# Access Compliance Report

## Public Rights-of-Way

### (Curb Ramps)

Intersection ID: N/A	Main Street: NEW_FASHION_WY	Cross Street: N/A	Location: E
ADA ID: 51BD0BB48C46	Ramp Type: Perp	Initial Pass/Fail: Fail	Overall Compliance: No
Severity Score: 12.5			
Codes/Mitigation Info/Possible Solution		Field Measurements/Component Compliance

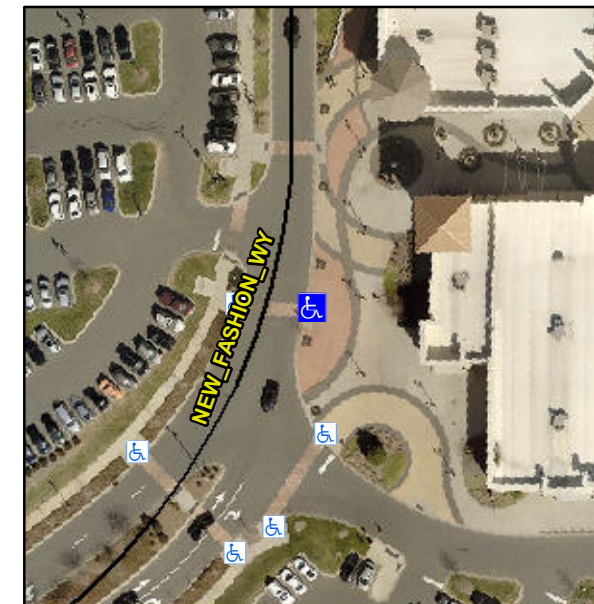
**R304.2.2**

Compliance	Description	Data	Compliance	Description	Data
N/A	Ramp Length (in)	59.0	No	Ramp Slope (%)	9.0
Yes	Ramp Width (in)	48.0	Yes	Ramp XSlope (%)	1.2
N/A	Flare Type LT	N/A	N/A	Flare Type RT	N/A
N/A	Flare Slope LT (%)	N/A	N/A	Flare Slope RT (%)	N/A
N/A	Flare Traversable LT?	N/A	N/A	Flare Traversable RT?	N/A
N/A	Landing Length (in)	N/A	N/A	DWS Provided?	N/A
N/A	Landing Width (in)	N/A	N/A	DWS Contrast?	N/A
N/A	Landing Slope (%)	N/A	N/A	DWS Length (in)	N/A
N/A	Landing X Slope (%)	N/A	N/A	DWS Full Width?	N/A
N/A	Landing Curb? (Y/N)	N/A	N/A	DWS Offset (in)	N/A
N/A	Shared Landing?	N/A			
N/A	Gutter Ponding?	N/A	N/A	Gutter Slope (%)	N/A
N/A	Gutter Lip Ht (in)	N/A	N/A	Gutter X Slope (%)	N/A
N/A	Painted X Walk1?	Yes	N/A	Painted X Walk2?	N/A
	X Walk 1 Direction	To NW		X Walk 2 Direction	N/A
N/A	X Walk 1 Width (in)	80.5	N/A	X Walk 2 Width (in)	N/A
	X Walk 1 Slope (%)	0.8		X Walk 2 Slope (%)	N/A
	X Walk 1 X Slope (%)	1.4		X Walk 2 X Slope (%)	N/A

**Remove & Replace Entire Ramp.**
